Project	IEEE 802.16 Broadband Wireless Access Working Group < http://ieee802.org/16 >	
Title	Comments on second stage access station selection	
Date Submitted	2008-03-18	
Source(s)	Kanchei (Ken) Loa, Yi-Hsueh Tsai, Yung-Ting Lee, Hua-Chiang Yin, Shiann-Tsong Sheu, Youn-Tai Lee	Voice: +886-2-66000100 Fax: +886-2-66061007 loa@iii.org.tw
	Institute for Information Industry 7F, No. 133, Sec. 4, Minsheng E. Rd., Taipei City 105, Taiwan	
Re:	IEEE 802.16-08/007: "IEEE 802.16 Working Group Letter Ballot Recirc #28b: Announcement"	
Abstract	This contribution proposes to modify second stage access station selection	
Purpose	Text proposal for 802.16j Draft Document.	
Notice	<i>This document does not represent the agreed views of the IEEE 802.16 Working Group or any of its subgroups. It represents only the views of the participants listed in the "Source(s)" field above. It is offered as a basis for discussion. It is not binding on the contributor(s), who reserve(s) the right to add, amend or withdraw material contained herein.</i>

Comments on second stage access station selection

Kanchei (Ken) Loa, Yi-Hsueh Tsai, Yung-Ting Lee, Hua-Chiang Yin, Shiann-Tsong Sheu, Youn-Tai Lee
Institute for In

Figure 1 Access Station Changed

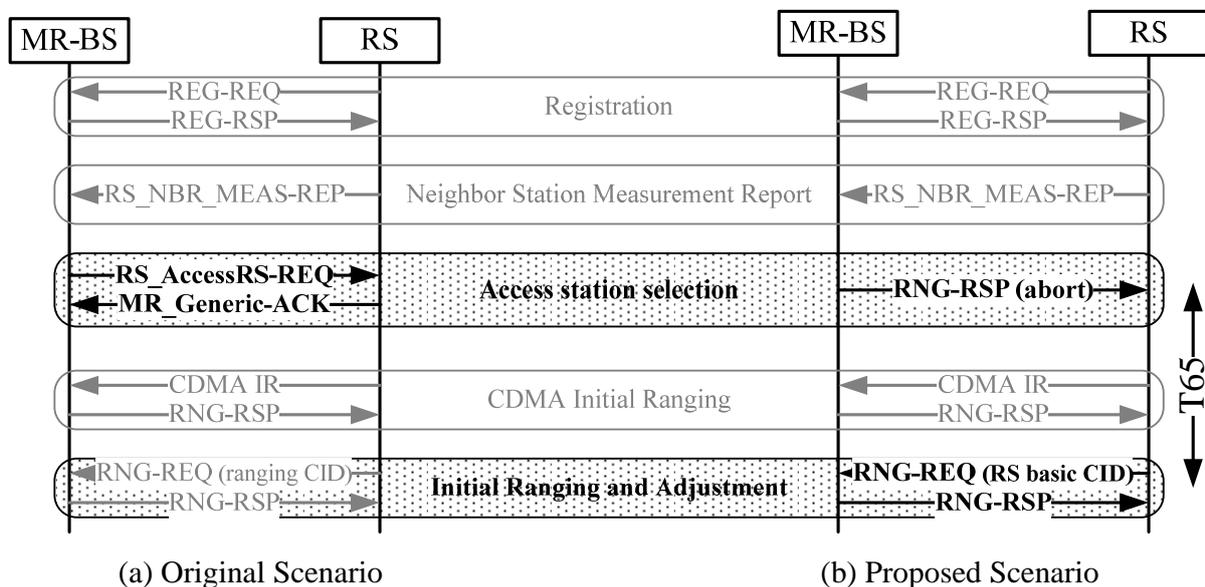
This contribution proposes to optimize the RS network entry by replacing the RS_Access-REQ message with the RNG-RSP message and skip the access station selection phase if there is no change for the access station. In P802.16j/D3, the “RS access selection request (RS_Access-REQ) message” is used by an MR-BS to indicate the access station the RS is supposed to attach to. Since this message is only used for RS network entry, which occurs infrequently, and could be easily replaced by “ranging response (RNG-RSP) message” that has been used for similar purpose during the MS network entry. We proposes to replace the “RS_Access-REQ message” by the “RNG-RSP message with status abort and Preamble Indexes TLV” to indicate the access station the RS shall attach to. If the current access station is changed, the MR-BS shall start T65 timer and send the RNG-RSP message which contains abort status and Preamble Indexes TLV to the RS to indicate the preamble index of a newly selected access station. (Time reference of T65 is “Wait for RNG-REQ message with RS basic CID after sending RNG-RSP message which contains abort status and Preamble Indexes TLV”) The MR-BS and the RS shall perform network re-entry as described in 6.3.9 with the following modifications. Instead of using ranging CID, the RS shall send RNG-REQ message with the assigned RS basic CID to the new access station. The MR-BS may instruct the RS to omit phases by the RS network entry optimization TLV in the RNG-RSP message. (see Figure 1)

Figure 2 Access Station Unchanged

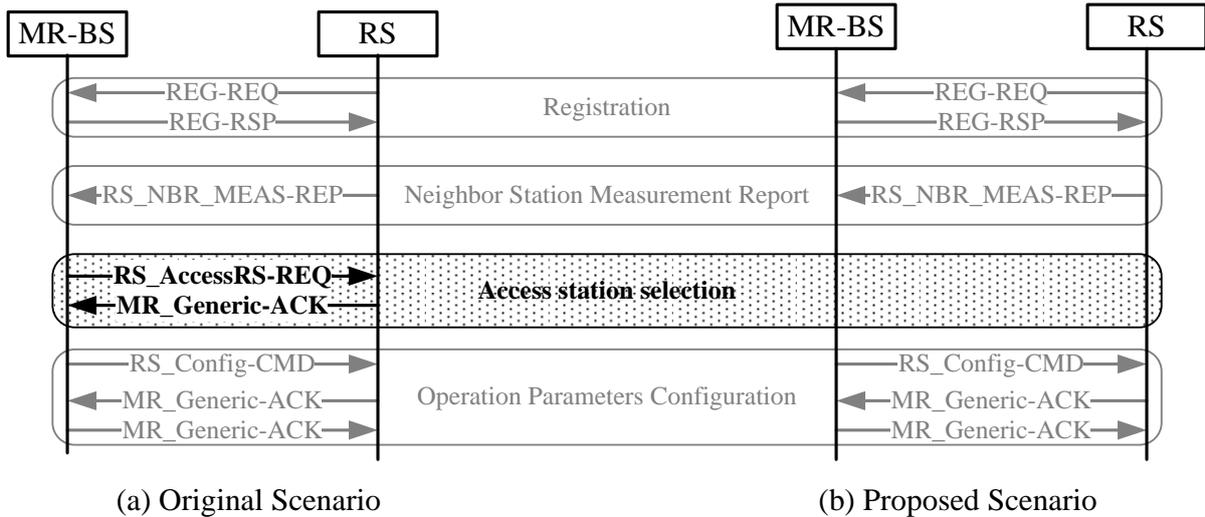
In addition, if there is no change for the access station, the MR-BS can send an “RS_Config-CMD message” immediately to signal the ending of the access station selection phase and the starting of the RS operational configuration phase. There is no need to go through RS_Access-REQ/MR_Generic-ACK iterations. (see Figure 2)

Figure 94b—Handling REG-RSP retransmission at an RS

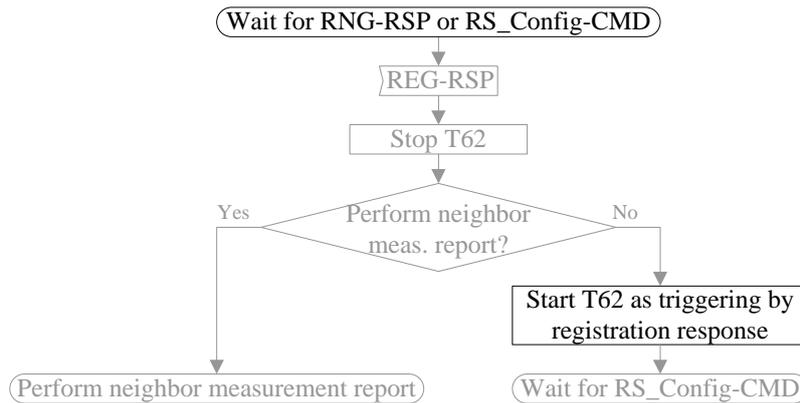
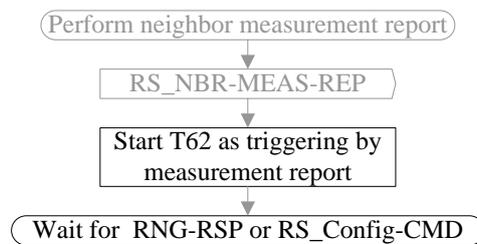
[Modified the Figure 94b as indicated:]

Figure 102c—Handling ~~RS_AccessRS-REQ~~ RNG-RSP first reception at an RS

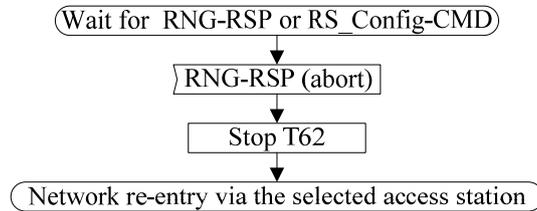
[Replace the Figure 102c as indicated:]

Figure 102d—Handling ~~RS_AccessRS-REQ~~ retransmission at an RS

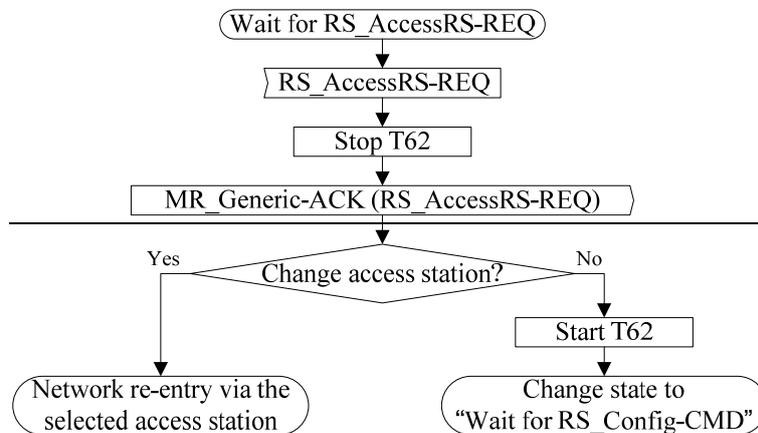
[Delete the Figure 102d as indicated:]

Figure 102e—Perform access station selection at an MR-BS

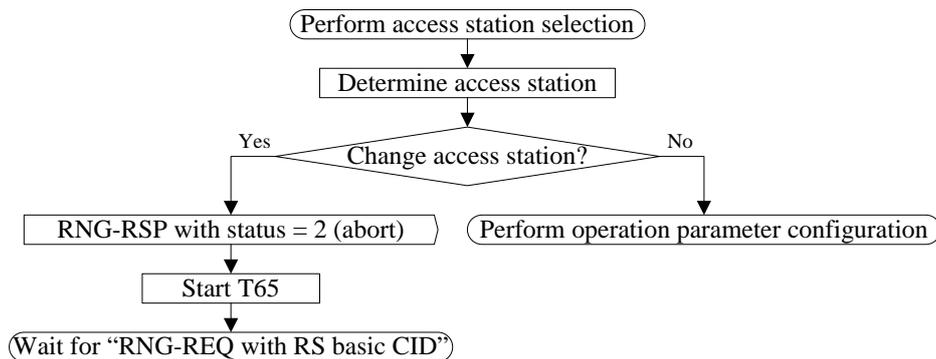
[Replace the Figure 102e as indicated:]

Figure 102e-1—Handling RS_NBR-MEAS-REP retransmission under “Wait for “RNG-REQ with RS basic CID”” at an MR-BS

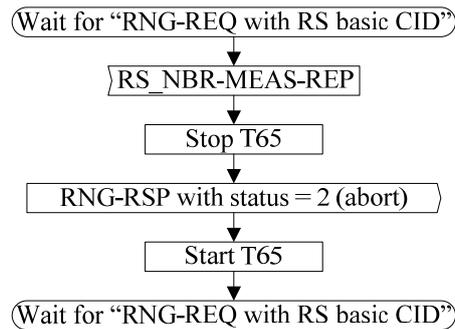
[Insert the following figure as indicated:]
